STS-104 FLIGHT READINESS REVIEW

Presenter:
	Organization/Date: Orbiter/06-28-01

AGENDA

SUPPLY WATER SYSTEM

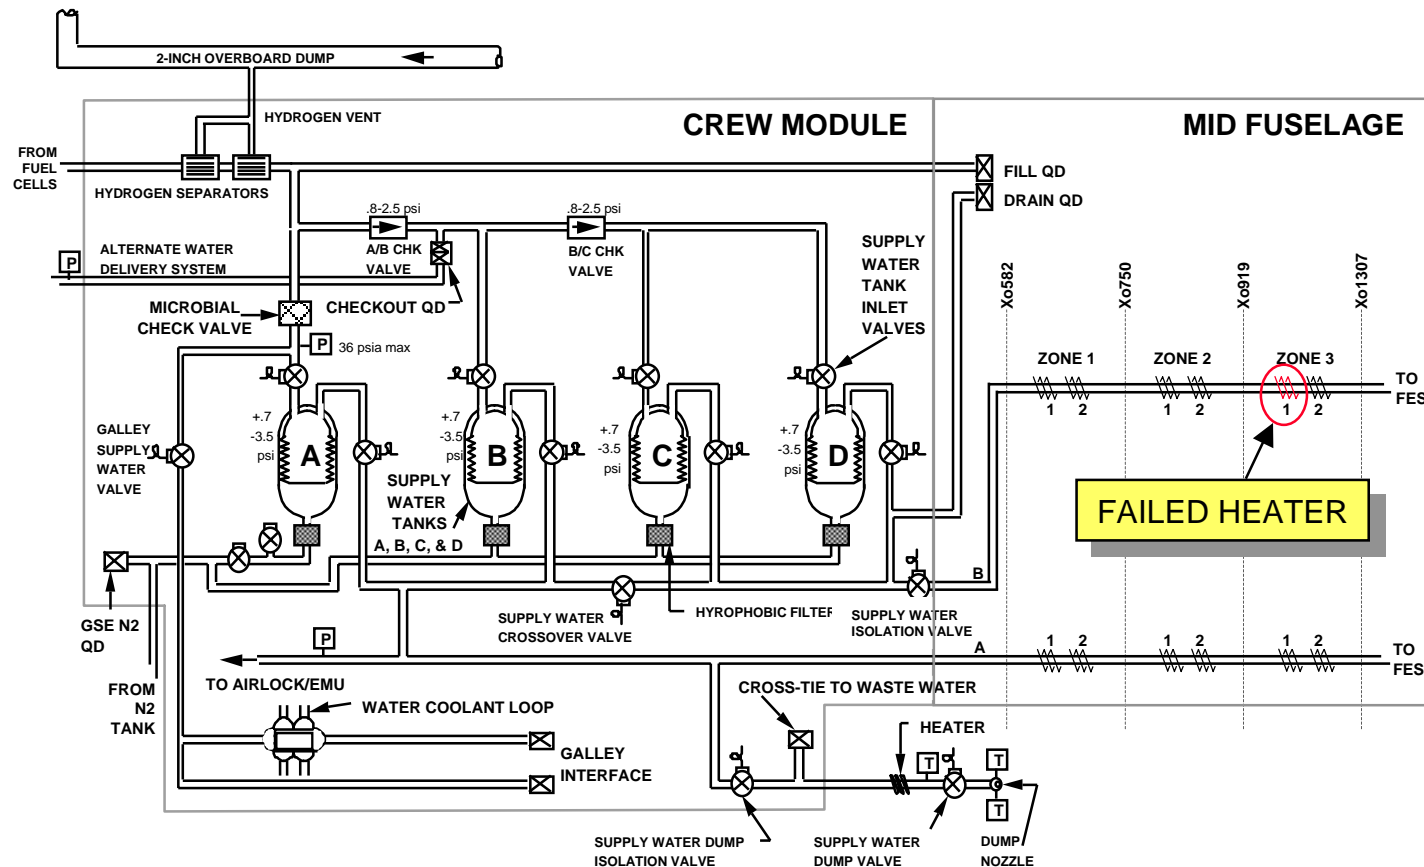
- FES B (stbd) supply H₂O feedline heater 1 zone 3 failed off and the line temperature (V63T1875A) dropped to about 52°F

- Without corrective action, loss of a second heater may result in FES feedline freezing and potential loss of one of the FES systems

- Water line temperature in zone 3 drifted to around 52°F at MET 000:13:00 (vs 65F to 90F typical) indicating heater failure
 - No heater cycles seen following application of heater string 1 power post-launch
- Heater is required to prevent water line freezing in cold attitudes
- There are two heater strings per feedline

- Analysis, based on planned STS-100 docked attitude, predicted that water line temperature would reach 32°F within three hours with no heater
- Heater string 2 was enabled at MET 000:17:20 and system performed nominally
- A contingency line purging procedure was in place in the event of a second heater string failure

- Post-flight troubleshooting found a broken wire at the heater ground point

- FES heater string operation was verified as part of in flight checkout OMRS file IX requirements during the last OV-104 mission (STS-98)
- In the event of a heater failure, the redundant heater string may be used
- With loss of both heater strings, a contingency procedure to purge the affected line is available to prevent freezing and allow recovery of the system for entry

WATER SPRAY BOILER SYSTEM SCHEMATIC

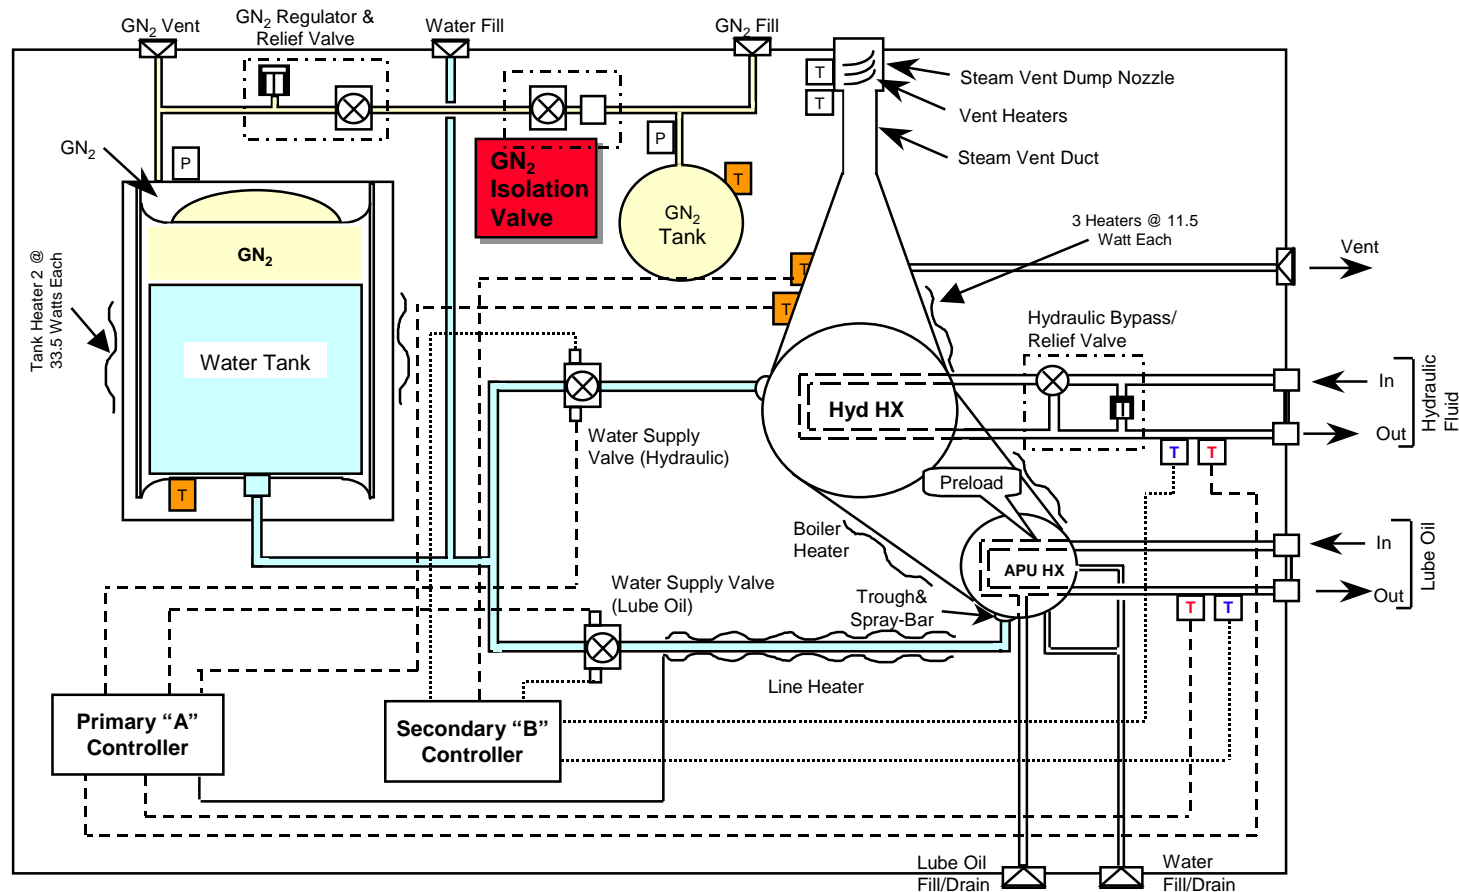
- WSB #3 temperatures for GN₂ tank, water tank and WSB core rose abnormally on controller B

- Failure might result in loss of WSB cooling and therefore loss of one APU

- WSB 3 was switched, as planned, from controller A to controller B approximately 24 hours after launch
 - Three WSB 3 temperature measurements rose unexpectedly over the next three days
 - GN₂ tank temp increased from 78°F to 83°F
 - Core temp increased from 72°F to 77°F
 - Water tank temp increased from 75°F to 78°F
- WSB 3 was switched back to A controller after 77 hrs on the B controller
 - Temperatures recovered to normal

- Post-flight troubleshooting has isolated the source of the heat to the GN₂ isolation valve
 - A failure within the controller caused the isolation valve to remain powered and act as a heater, supplying 37.5 watts of energy
 - Multiple single point failures within the controller can produce this failure; none are common to both A and B controller
- The controller has been removed and routed to NSLD for TT&E
 - The failure has been isolated to circuit board #8 where the output current for the GN₂ isolation valve is always on
 - The circuit board will be replaced with a spare
 - Failure analysis will begin on the failed circuit board

- OV-104 WSB operation was verified per OMRS test requirements
- In the event of a similar failure, the WSB will be switched to the alternate controller

VERNIER THRUSTER R5D S/N 401

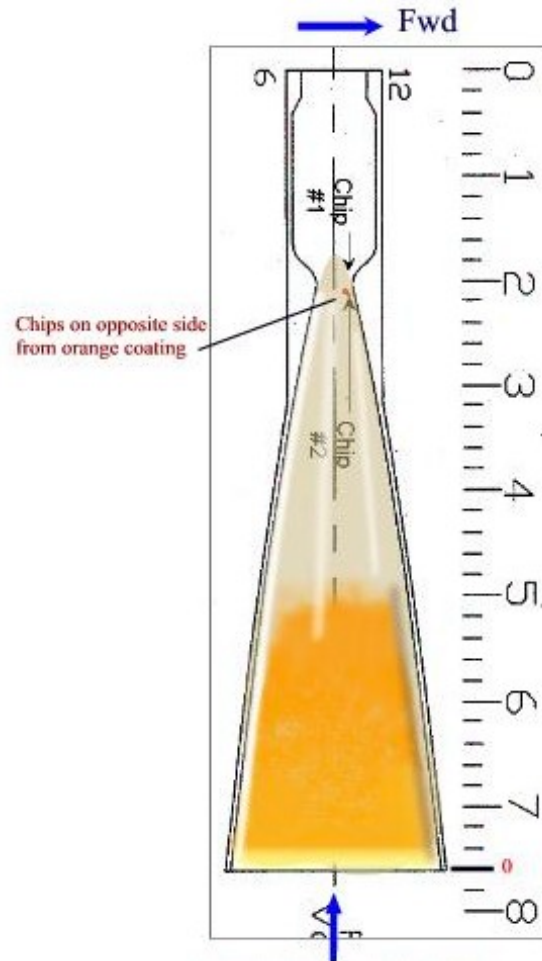
- RCS vernier thruster S/N 401(R5D) had low combustion chamber pressure (Pc) indications on several pulses in preparation for undocking with ISS

- Potential for deselection of R5D vernier thruster

- Vernier thruster R5D chamber pressure was intermittently low prior to undock through final use prior to entry
 - Pc varied from low of 50 psia to nominal ~108 psia
- RM did not deselect R5D
 - Vernier thruster deselects when Pc is < 26 psia in presence of an RPC fire command for three samples

- Visual inspection found bright powdery-orange area in divergent part of nozzle
 - Unable to obtain sample (would not scrape off using teflon tool or come off using IPA/wipe)
- Borescope inspection of combustion chamber was performed
 - No sign of contamination on injector
 - No evidence of blockage at Pc port
 - Existing chip in throat (which was .04" x .04" previously) is now .08" x .09"
- The thruster was removed and there were no external abnormalities on Pc tube
- The thruster was shipped to WSTF
 - TT&E is underway, initial results expected by 7/9/01

- Complete TT&E at WSTF
- For upcoming missions, a vernier thruster with the same signature will not be fired until the failure analysis is complete and the cause is understood

- No indication of low Pc on OV-104 vernier thrusters during last flight (STS-98)
 - Pc tubes flushed at OMDP three flights ago
- Significant qual test data indicates low Pc not detrimental to thruster
- If the same signature were to recur, the thruster would be deselected
 - Not a safety of flight issue
 - Possible effect on reboost mission objectives

First Flight of MCR 17177 Freon Relief Line Reroute

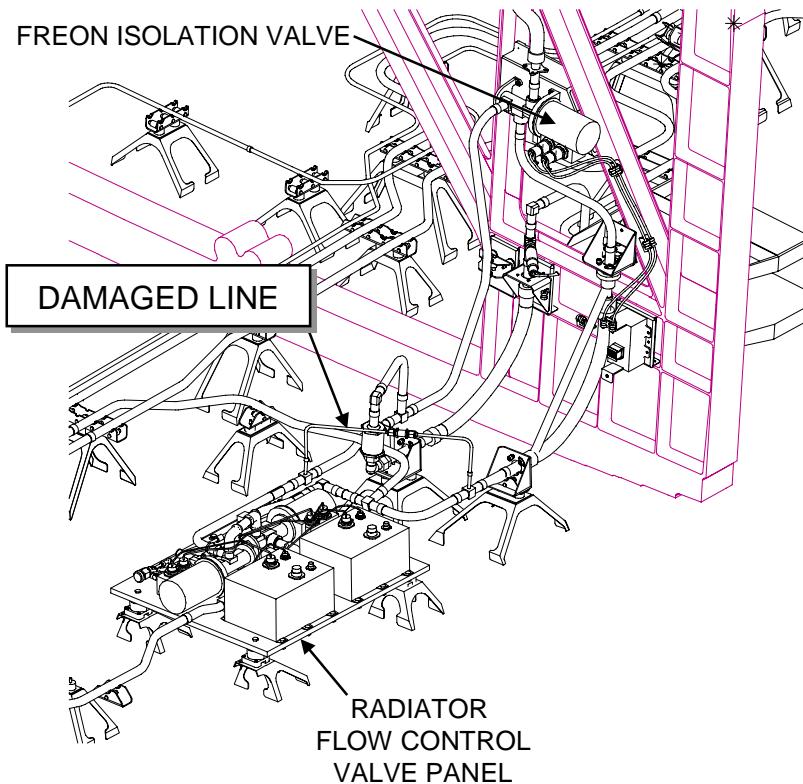
- Reroutes the freon loop #2 (starboard) 1/4" relief line which was susceptible to damage during maintenance operations

LINE REROUTED UNDER EXISTING PLUMBING

First Flight of MCR 19376 Lightweight Locker Upgrades:

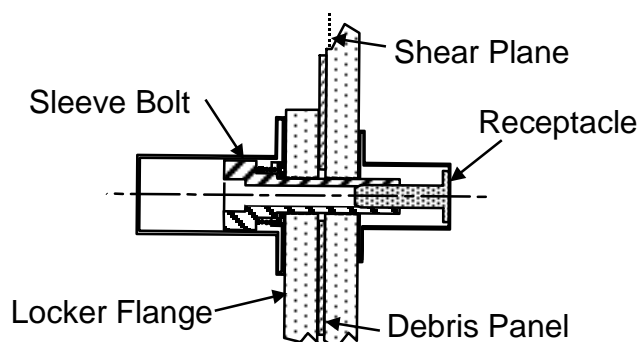
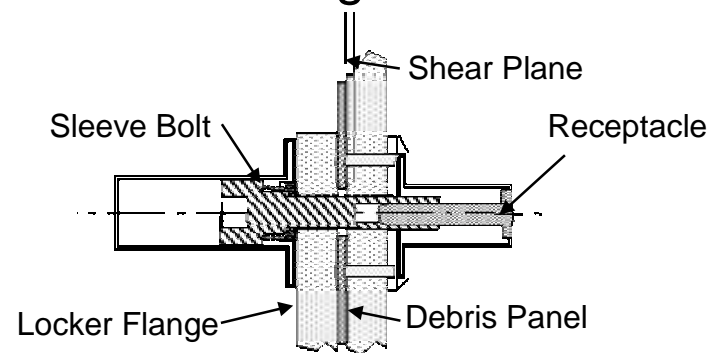
- Previous design of mid-deck locker sleeve bolts do not meet 20g crash load requirement at lower positions (OVEI waiver approved)
- The lockers, debris panels and thermal panels have been modified to ensure that the solid fastener cross-section is positioned at the locker-to-structure shear plane
 - Lockers were simultaneously modified to add double acting latches and shims for better fit of fire port extension hose
- 18 lockers as well as MA9N soft stowage bag mounting panel have been modified to the new configuration

First Flight of MCR 19494 Drag Chute Reefing Lanyard

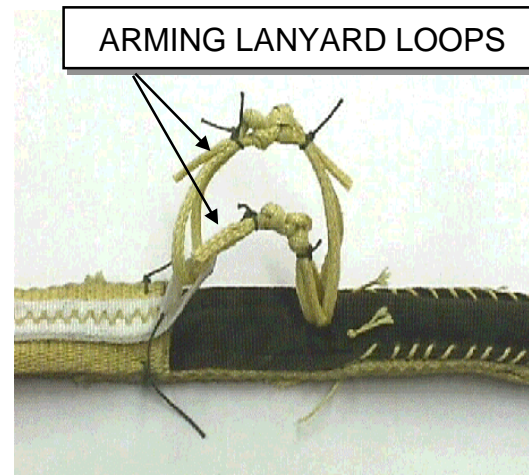
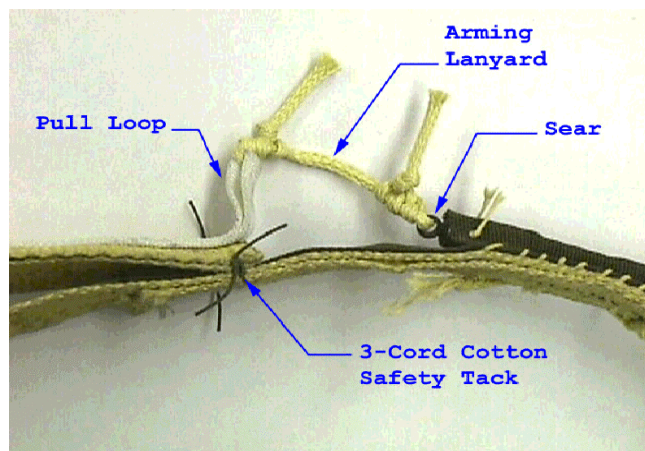
- Revises reefing release actuation lanyard to provide additional redundancy
 - Provides second (longer) lanyard to actuate the reefing sear (cutter) in the event the first lanyard fails
 - Corrective action from one sear not firing on STS-96 deploy

PREVIOUS CONFIGURATION - SINGLE LANYARD NEW CONFIGURATION - TWO LANYARD LOOPS

First Flight of MCR 23021 MEDS Cooling Vent:

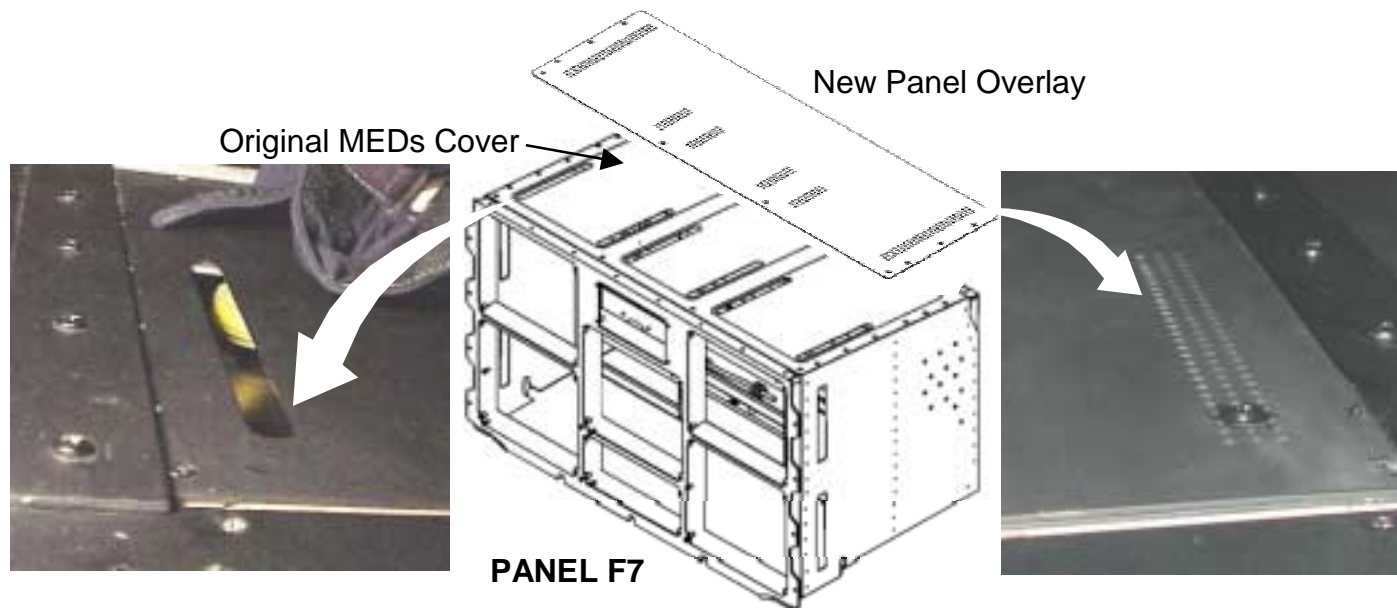
- Installs a new closeout overlay panel on the forward upper console which mitigates risk of damage from a lightning strike
 - Temporary 1/2 size overlay panel is installed over the existing upper F7 closeout panel
 - Eliminates requirement for an EMI waiver

OV-103 LH₂ Feedline Fasteners

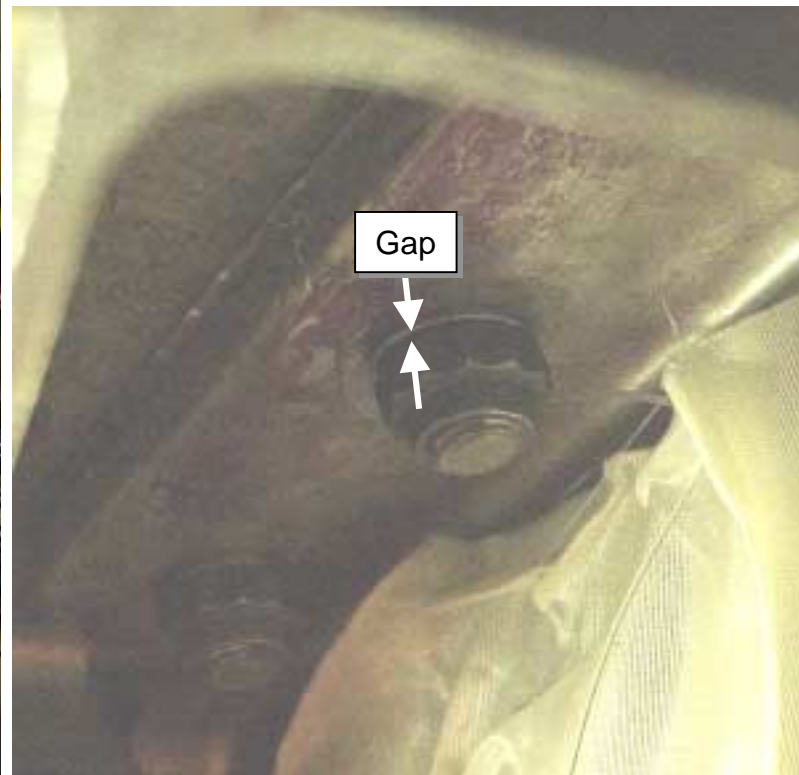
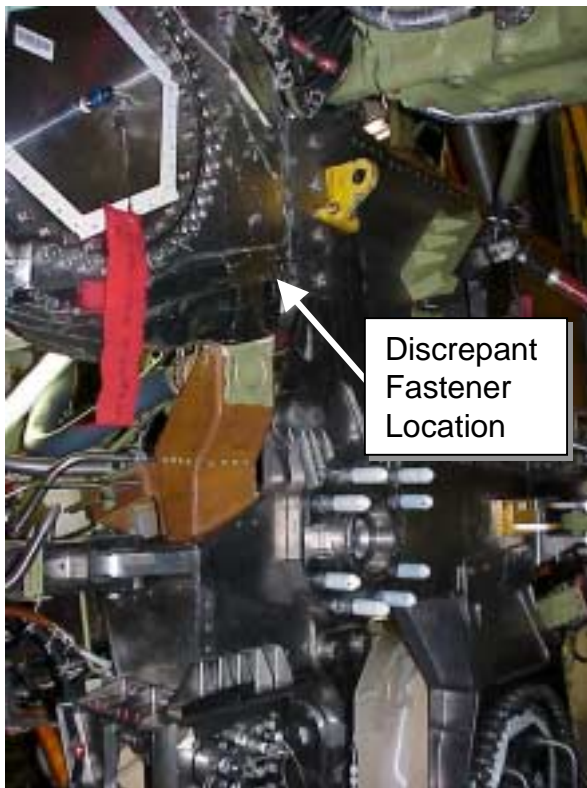
- Gap noted under a fastener head and nut on OV-103 LH₂ feedline support

- Loss of preload raises concern for loss of fasteners that could affect structural integrity

- During V30 structural inspection on OV-103 MPS LH₂ feedline support structure, a discrepant fastener was found
 - Gap under the fastener head was 0.008"
 - Gap under nut was 0.023"
 - Breakaway torque was 30 in-lbs (460-540 in-lbs required)
- Further investigation revealed fastener torque was below specification on all of fasteners on this feedline support

- All OV-104 feedline support fasteners were inspected for thread engagement and gaps and torque was checked on accessible fasteners
 - All of the bolts had proper engagement with lock nut
 - Six small gaps, 0.010" maximum, all less than 180 degrees, implying gaps caused by hole angularity
 - 38 of 81 bolts torque checked – 32 in range, 6 with reduced torque, all at least 60% of specified range

- Bolts are fully engaged into nut locking features
- No pre-load required for this application – no stress margin concern

799 ACTIVELY DRIED TILES

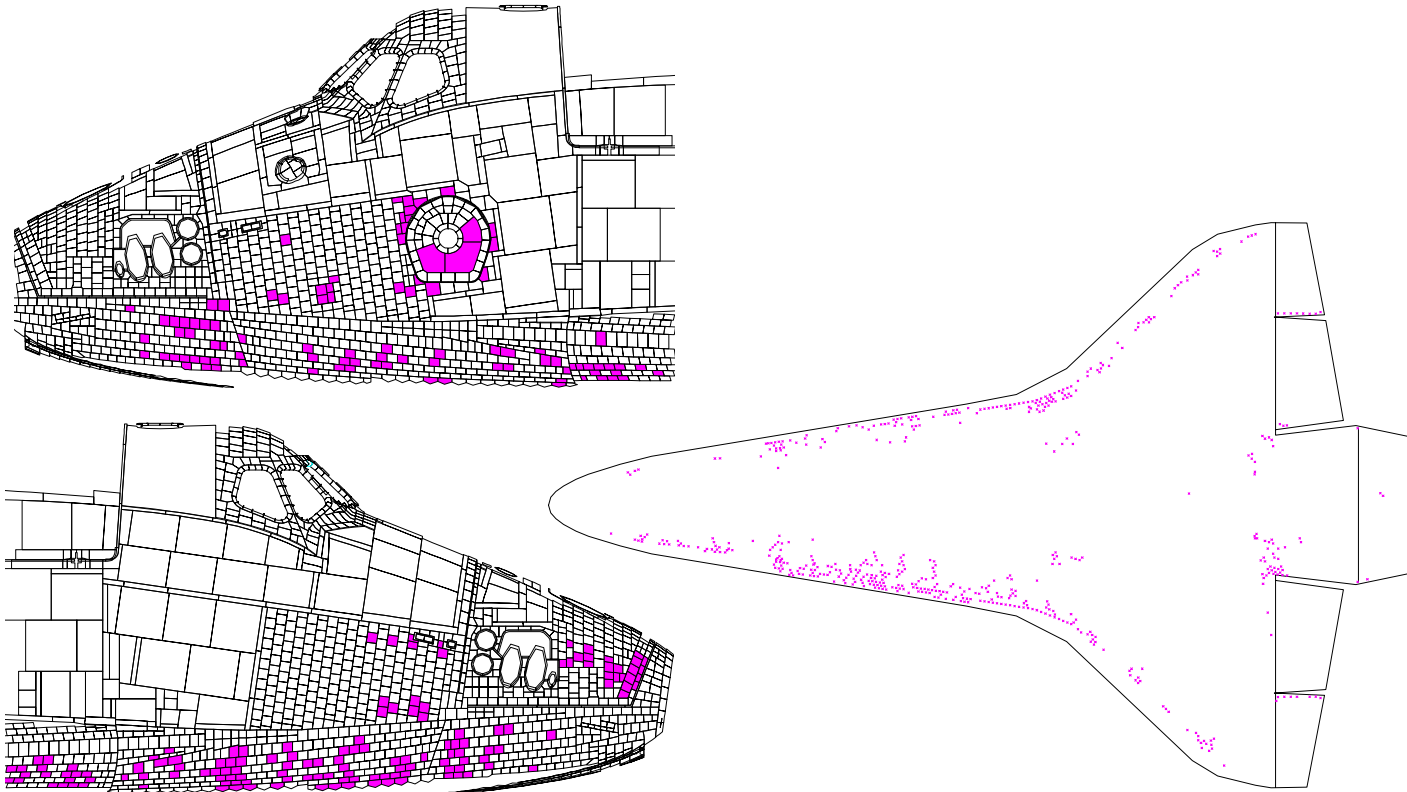
- OV-104 thermal protection system tiles were saturated with rain at Dryden following STS-98

- Presence of water during on-orbit operations can lead to freezing and tile fracture

- OV-104 was subjected to six days of heavy rain during DFRF operations
- Thousands of tiles were wet per IR scan at OPF roll in
- On 3/13/01, IR scan showed hundreds of tiles remained wet, so active tile drying was initiated
- By 5/4/01, 146 tiles remained wet per IR scan
 - Mainly in the RH chine area, LESS carrier panels, and outboard of LH MLGD – areas concentrated at the dripline or protected from direct application of heat lamps

- All OV-104 tiles have been dried and rewaterproofed
 - All wet tiles either dried naturally or were baked a minimum of four hours or until no visible water was escaping
 - Lab testing verified the drying time conservatively protects from potential damage due to freezing
 - Lab and on-vehicle core samples verify tile was successfully rewaterproofed

OMS POD VIBRATION

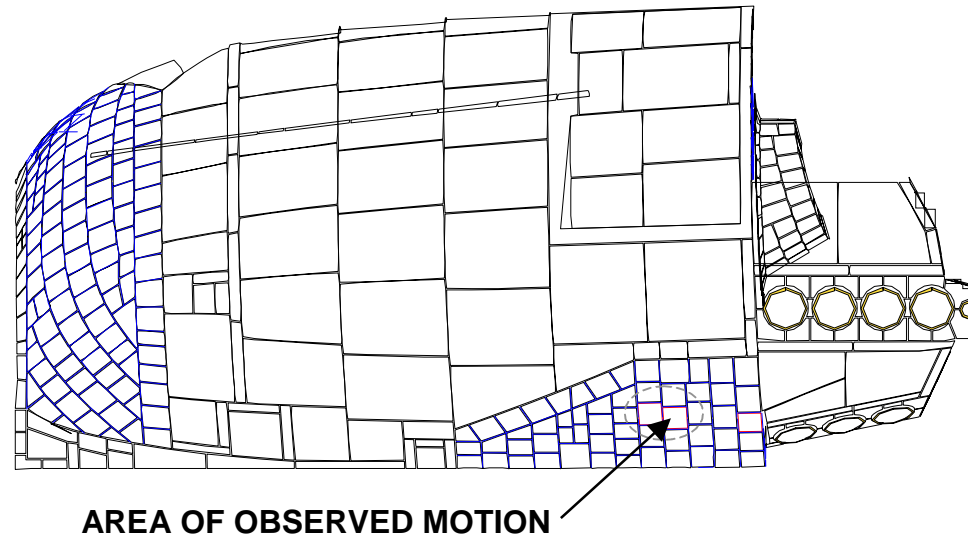
- Left OMS pod vibration observed on STS-100 launch film at SSME startup

- This type of motion could indicate the presence of an environment outside design predictions or could be causing TPS or structural damage

- Review of ascent film for STS-100 detected tile/structure motion with transient second order harmonics on the left OMS pod at the aft lower corner following SSME ignition
- The right OMS pod also showed definite motion, but of lesser magnitude
- Review of flight launch films from 20 previous flights showed that movement may be discernible on two other flights, but to a lesser magnitude

- The NASA JSC Image Science & Analysis Group performed film review analysis to define the amplitude and frequency of the LP04 pod movement
 - Two mid-panel points show 72-73 Hz oscillations with maximum peak-to-trough deflections of 0.7 inches (zero-to-peak amplitude of +/- 0.35 inches) in the out-of-plane direction

- OV-105 STS-100 left pod response is within MEI acoustic design environment predictions and within design capabilities for both structure and TPS
- No LP04 design differences or MR history that would cause a unique dynamic response
- Affected TPS and OMS skin structure show no indication of failure
